# MAL 6359

Chart MAL 6359 (Last Correction NE/2007 ) WGS 84 DATUM

Block for Chart MAL 6359 (A)

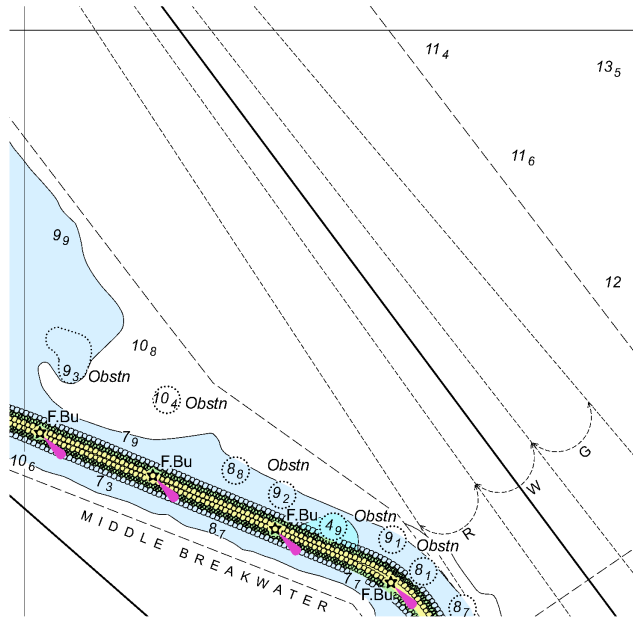
To accompany Malaysia Notices to Mariner No. 149 of 2020

Block for Chart MAL 6359 (B)

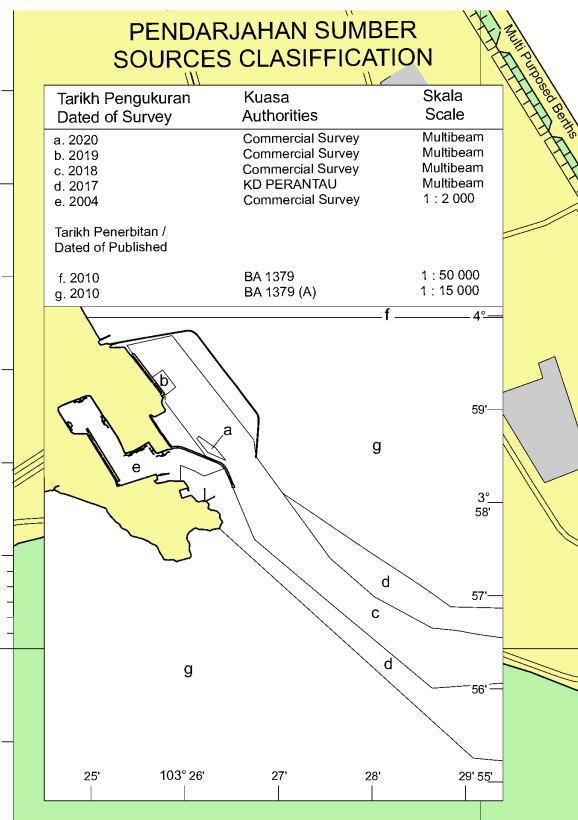
To accompany Malaysia Notices to Mariner No. 149 of 2020
